Independent School District #146
Buildings and Grounds Committee Meeting
9:00 AM on July 28, 2020
Barnesville High School
302 3rd Street South
Barnesville, MN 56379

FIELD CHANGE ORDER #11

TITLE: *Plumbing Review Revisions*

PROJECT: *Barnesville Public Schools
Additions and Remodeling*

A-1250

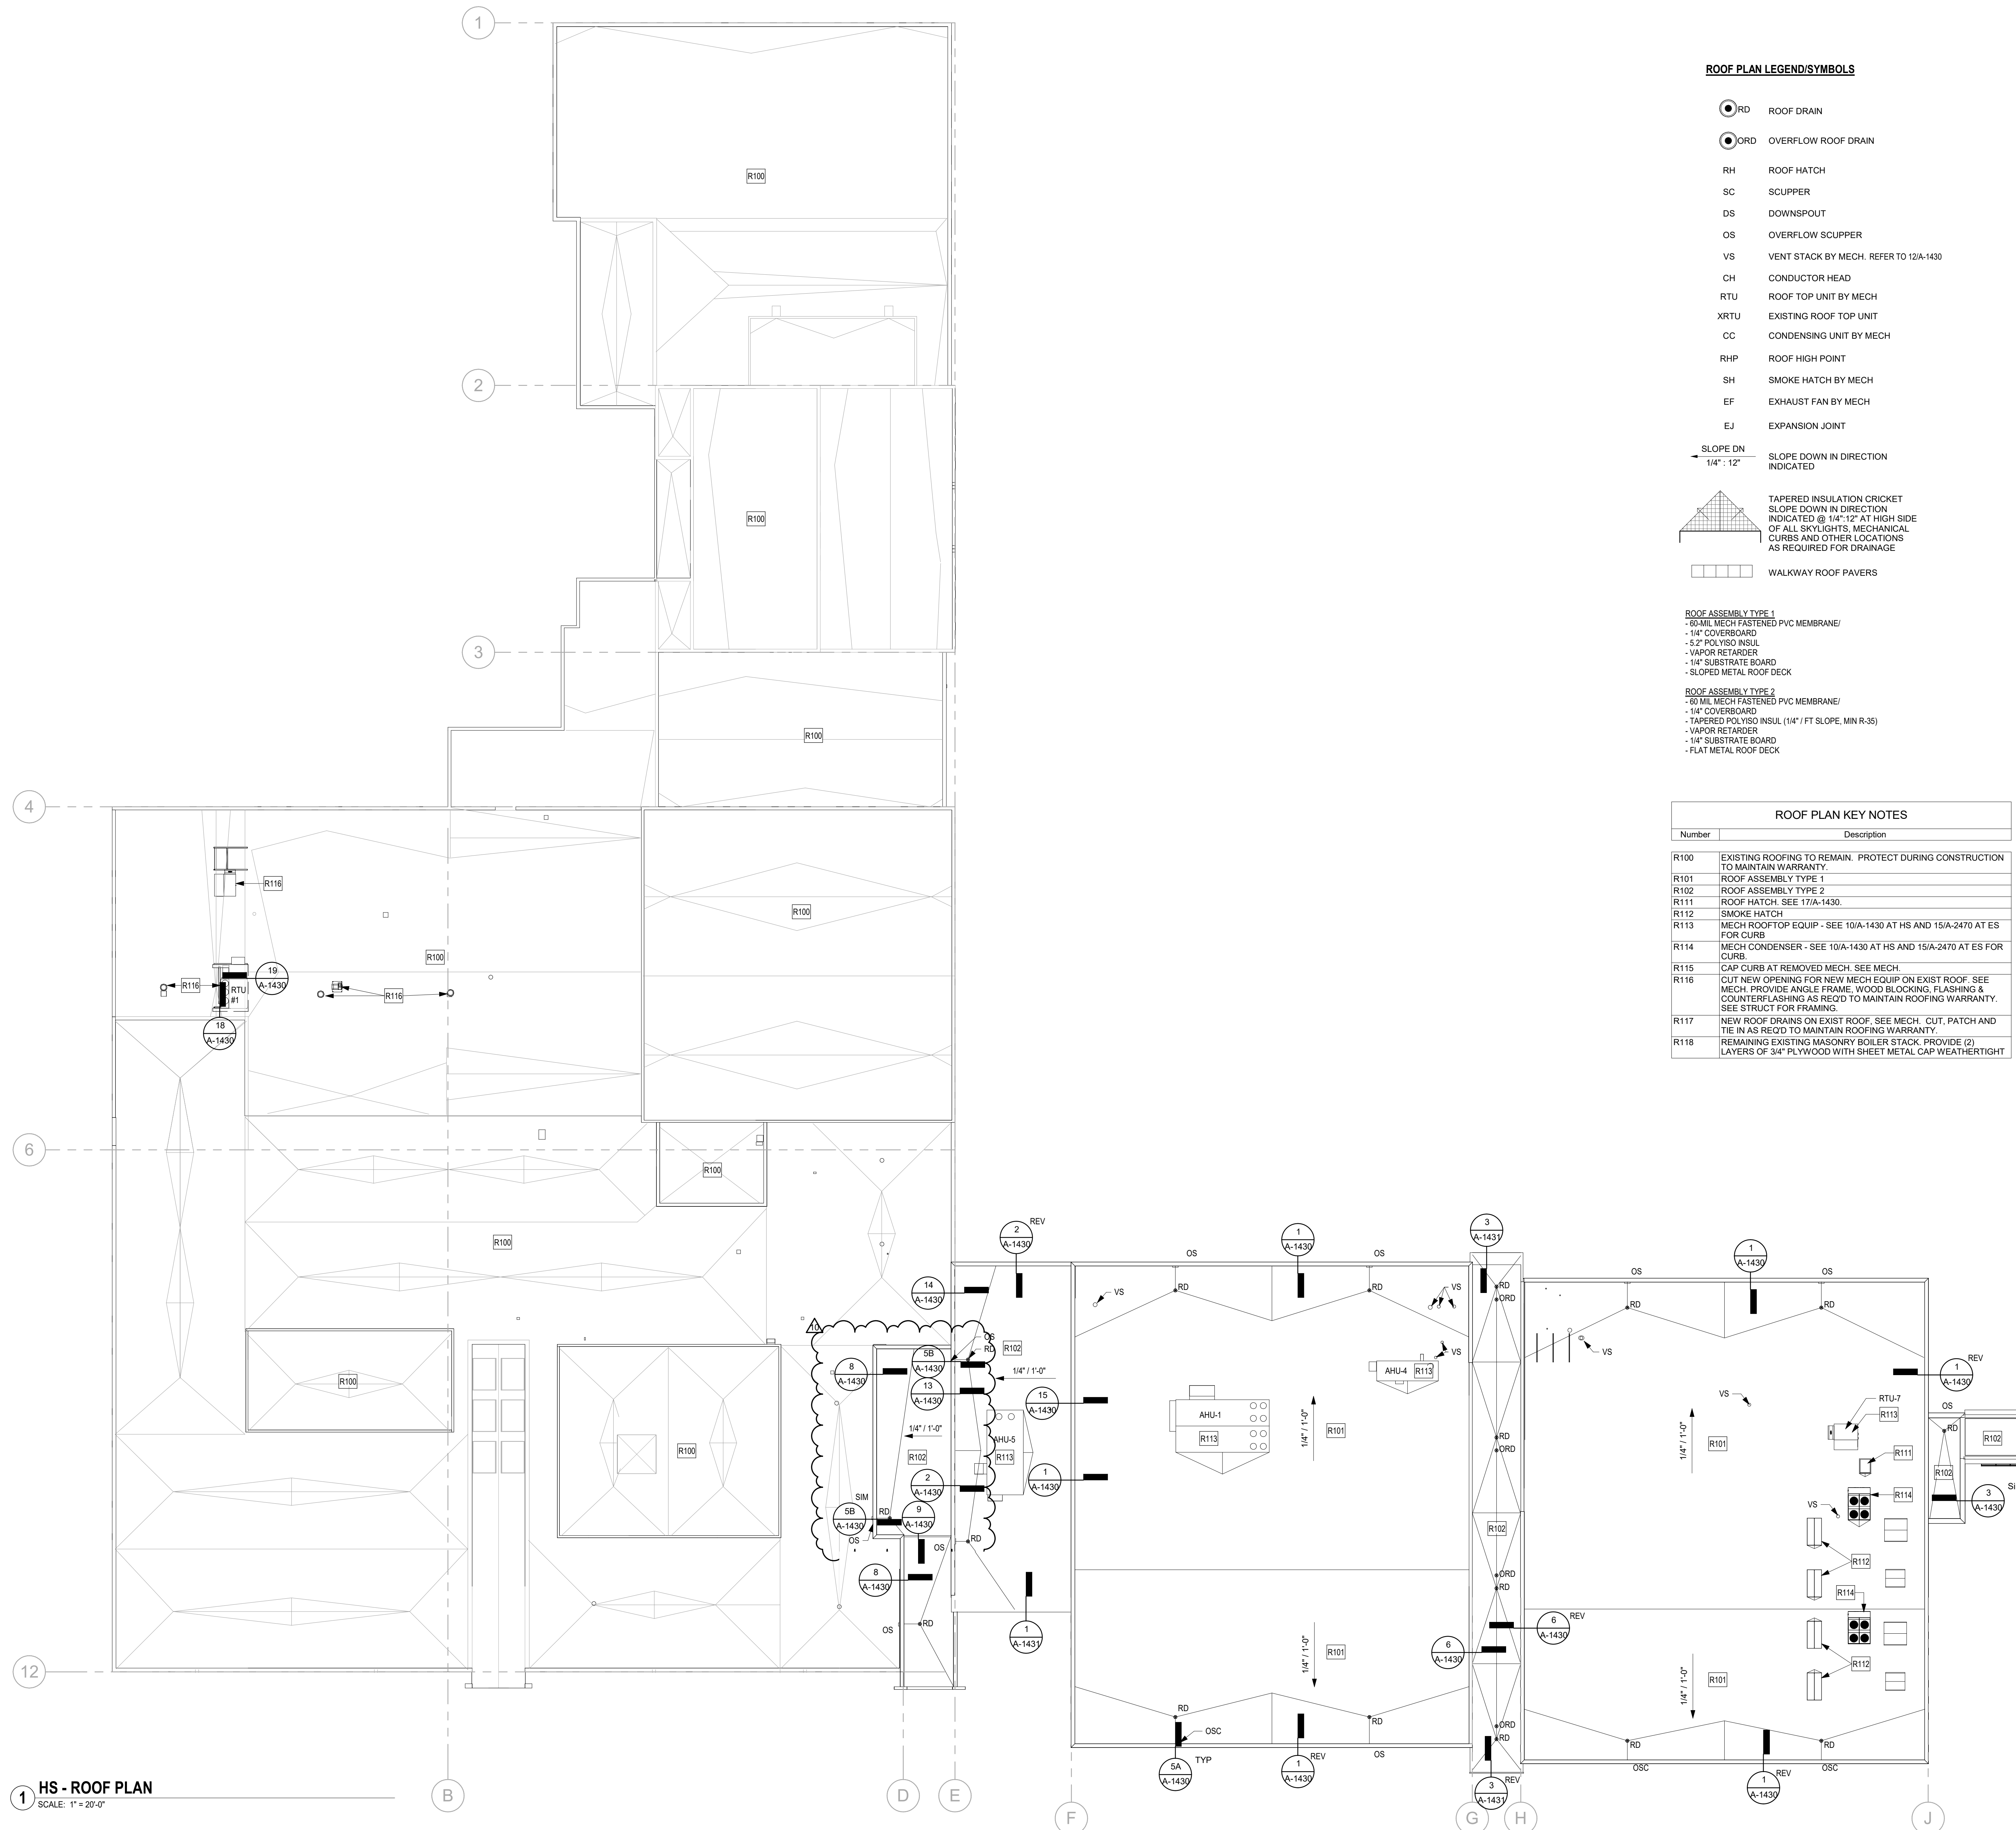
1. Refer to revised sheet A-1250 – HS – Roof Plan
 - a. Revise scupper location and associated tapered insulation slopes.

M-1231

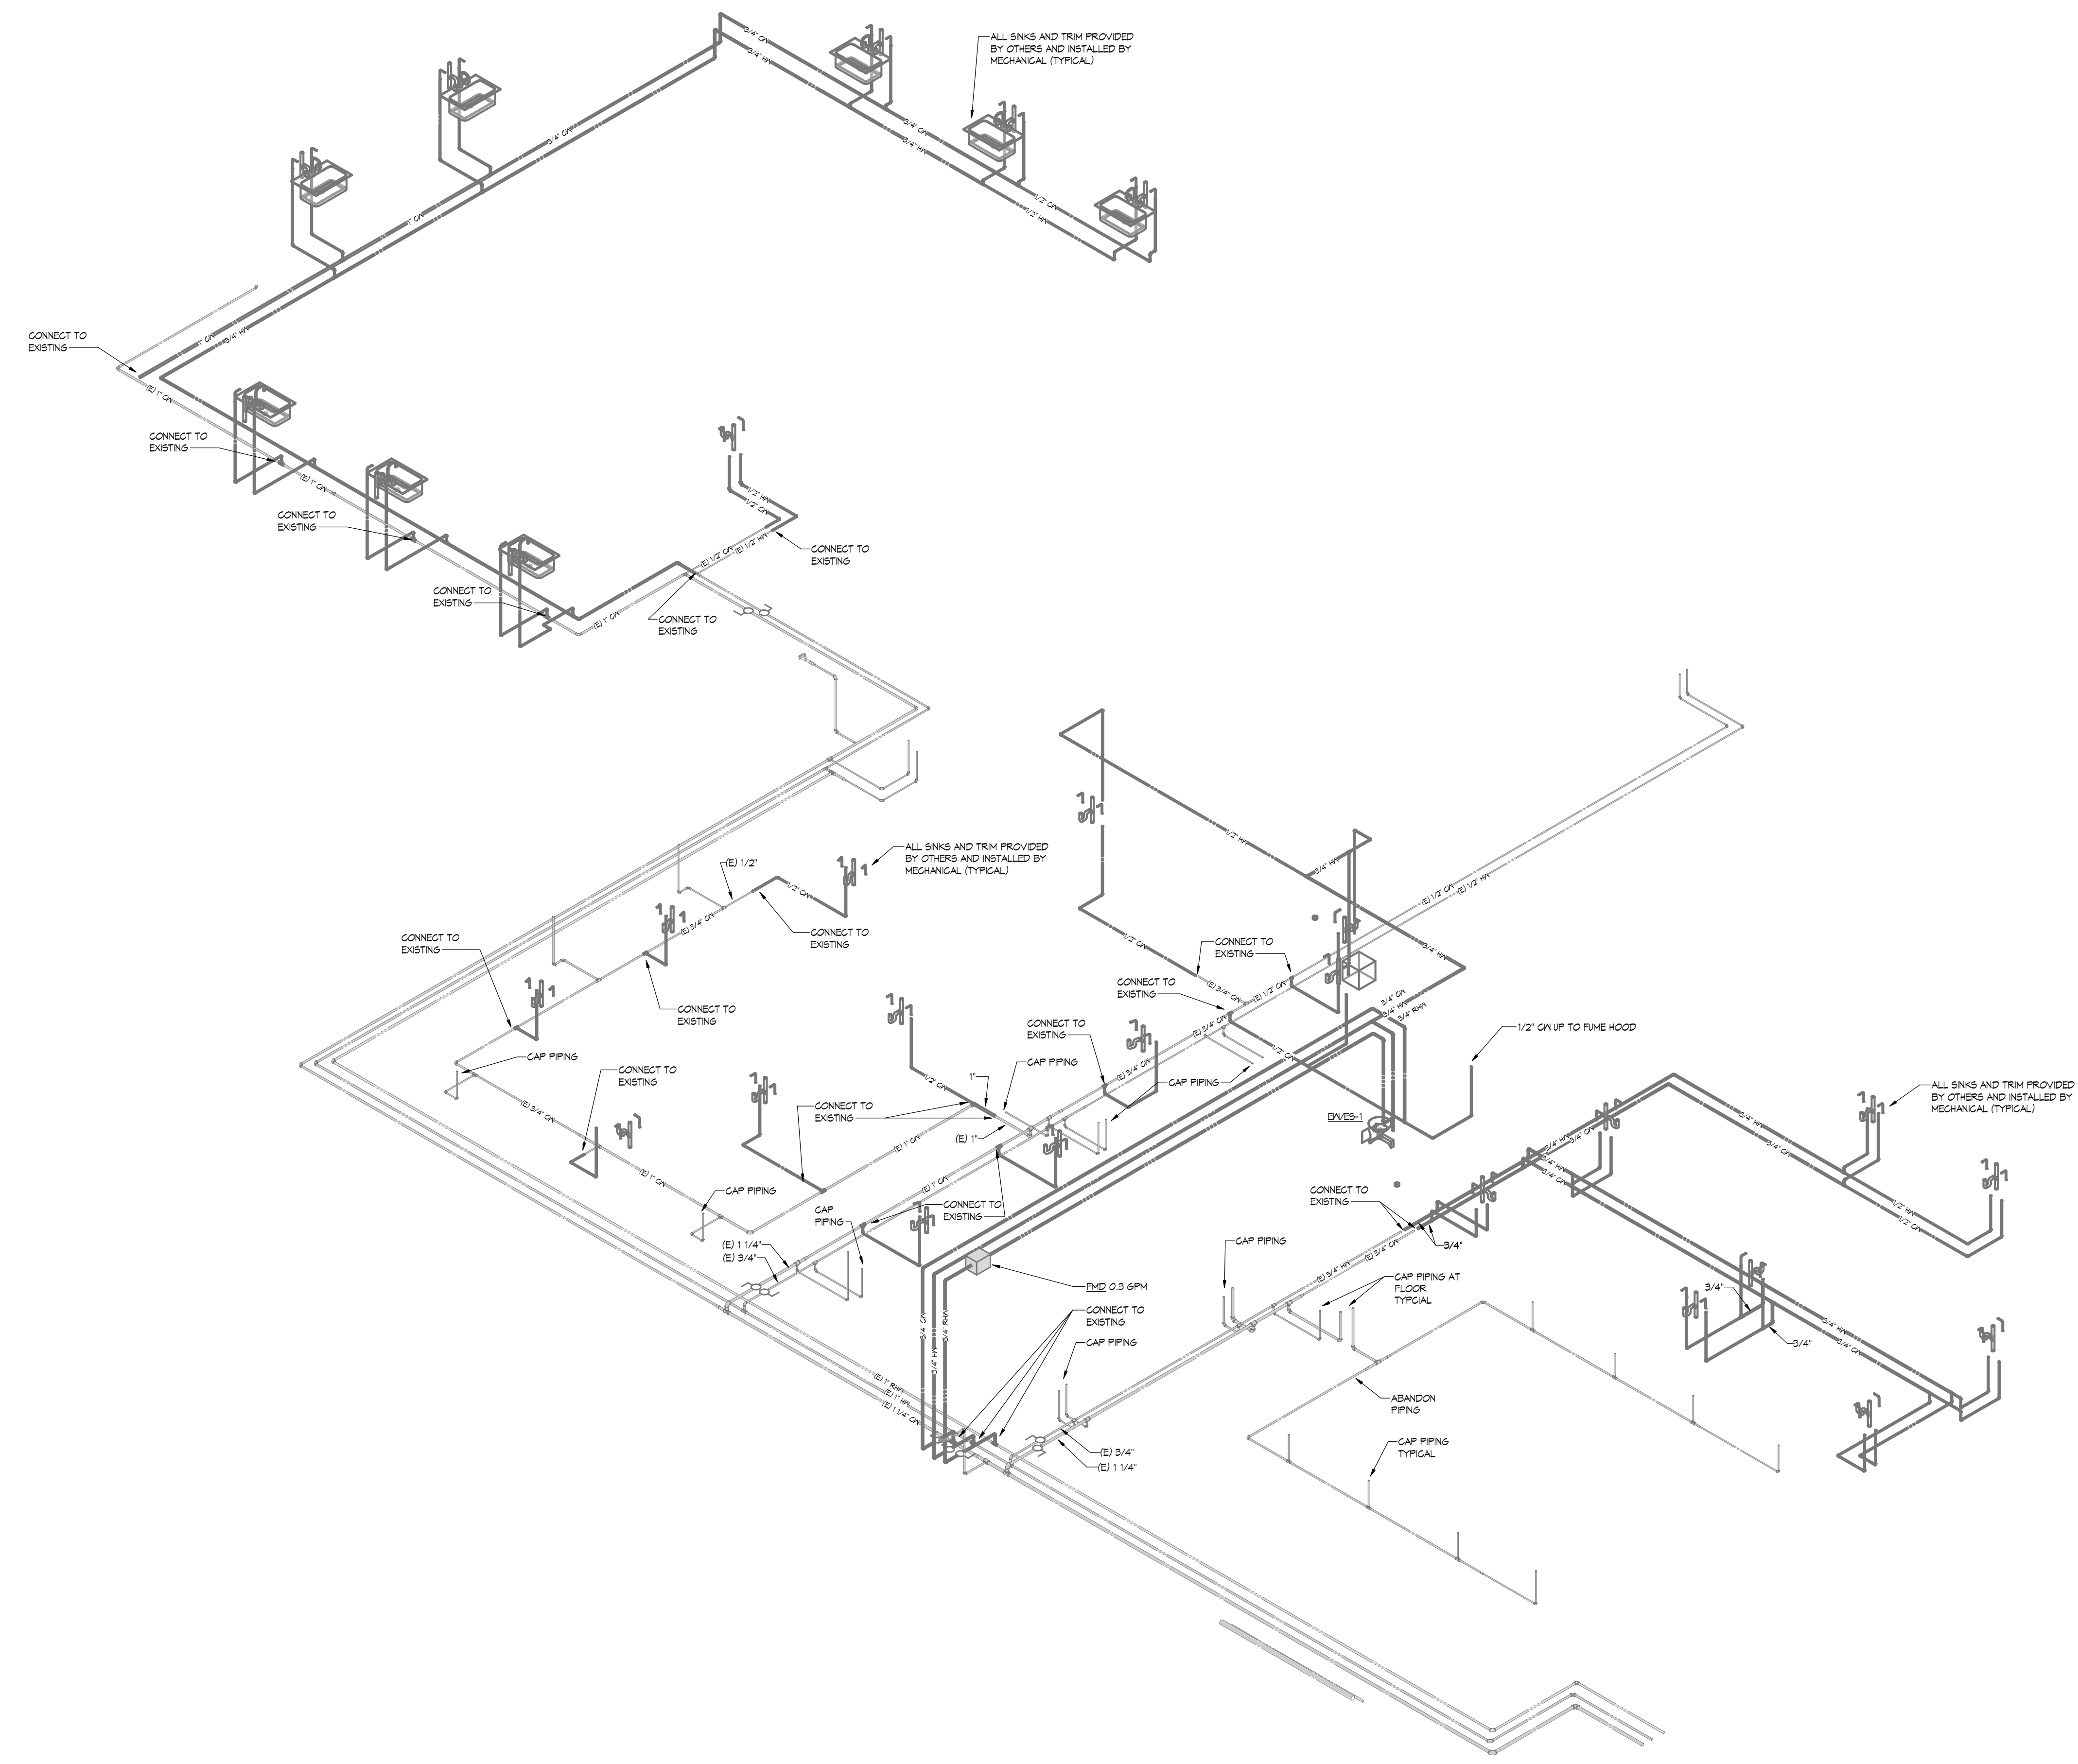
See attached sheets for revision to the science classroom area. EW/ES-1 shall be as follows:

EW/ES-1, Emergency Eye Wash/Shower Combination

All emergency eye/wash showers shall be packaged from the factory including all connecting piping between components. Field fabricated piping shall not be allowed. Speakman SE-1255, ABS plastic shower head, stainless steel receptor with face and eye wash spray heads. Push action stay open ball valve, chrome pull rod for shower, stainless steel push flag and foot treadle for face/eye wash, 1-1/2" stainless steel standard with floor flange and wall brace, universal combination emergency eye-wash and shower sign. Provide P-trap for connection of face/eye wash bowl into waste system. Furnish and install a Leonard Model TM-600, thermostatic mixing valve for each shower/eye wash. Controller shall be Chrome Plated finished thermostatic mixing valve with thermometer. Discharge temperature shall be set at 85°F. Provide integral stops and check valves for installation. Haws, Bradley, Encon, Stingray, Guardian, Speakman, Acorn (Murdock) are approved manufacturers.
